Baseline wander with FEC

Pete Anslow, Ciena

IEEE P802.3bs Task Force, SMF Ad Hoc, April 2017

Penalties vs X

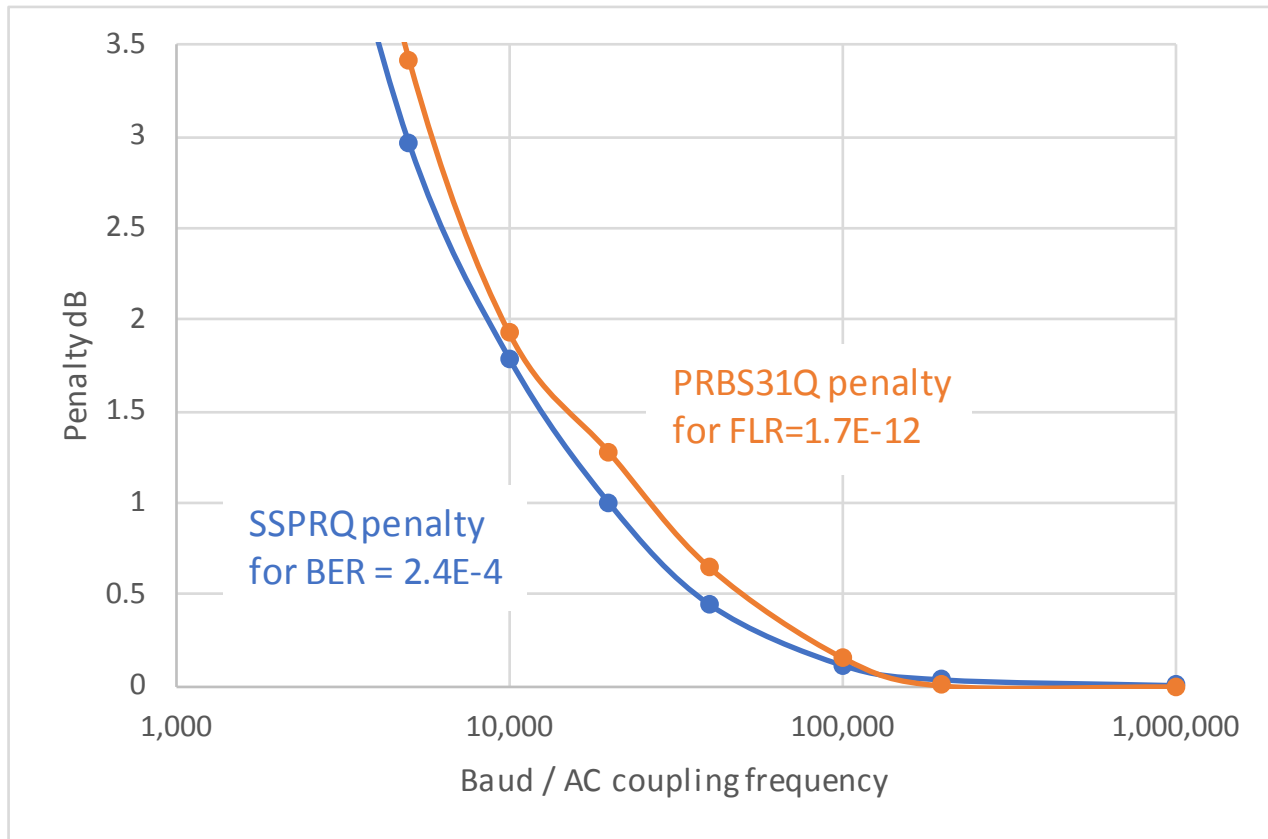
Comparison of the optical penalty for SSPRQ with BER = $2.4E-4$ and PRBS31Q assuming FEC with FLR = $1.7E-12$

The optical penalty for SSPRQ with pre-FEC BER = $2.4E-4$ has been compared with the optical penalty for PRBS31Q assuming FEC with FLR = $1.7E-12$ over a wide range of ratios between the symbol rate and AC coupling frequency showing very close agreement between the two penalties.
